## BOROUGH OF AMBLER COMMITTEE MEETING

**Finance & Planning Committee**

Reference: Final Land Development Plan Application Review  
John's Court LLC  
24-26 N. Ridge Avenue  
Tax Parcel #01-00-04153-00-4; Block 01038, Unit 043

Re: MCPC # 20-0081-002  
Plan Name: 24 & 26 North Ridge Avenue  
(1 lot comprising 0.25 acres)  
Situate: North Ridge Avenue and East Race Street  
Ambler Borough

Attachment B: Reduced Copy of Applicant's Proposed Site Plan

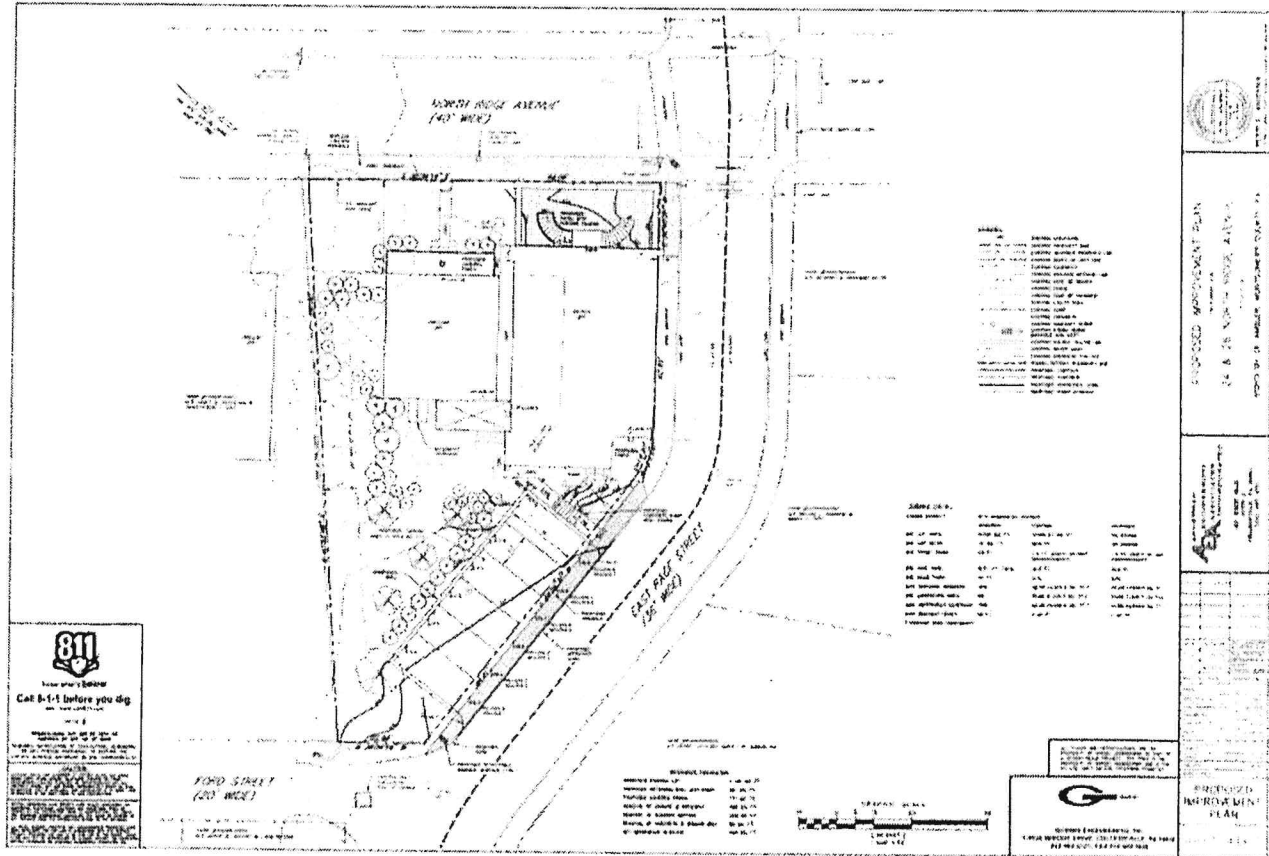
- A. Street trees. Per the Subdivision and Land Development Ordinance (SALDO §100.3), street trees are required along all existing streets at a rate of one per 40 linear feet of frontage or fraction thereof. It appears that the applicant has 268 linear feet of frontage, indicating a need for seven (7) street trees on the site. We suggest the applicant refer to the list of trees in the SALDO §100.6 for recommended trees that can be used as street trees.
- B. Tree preservation. It appears that the applicant plans to preserve several large trees along the north side of the property. We commend the applicant for the preservation of the large trees on the site.

- A. Proposed parking area. Two off-street parking spaces are required per dwelling unit per §27-2102. The applicant meets this requirement with the proposed parking area along Race Street. Although we generally do not support parking constructed adjacent to the sidewalk which will require drivers to back out into the street, we recognize that site constraints make it very difficult to add parking to the site. Considering that there are curves on East Race Street to both the immediate east and west of the proposed parking area, we suggest the applicant consider installing mirrors for visibility and evaluate any other options to improve safety for vehicles exiting the parking area and drivers traveling along Race Street.
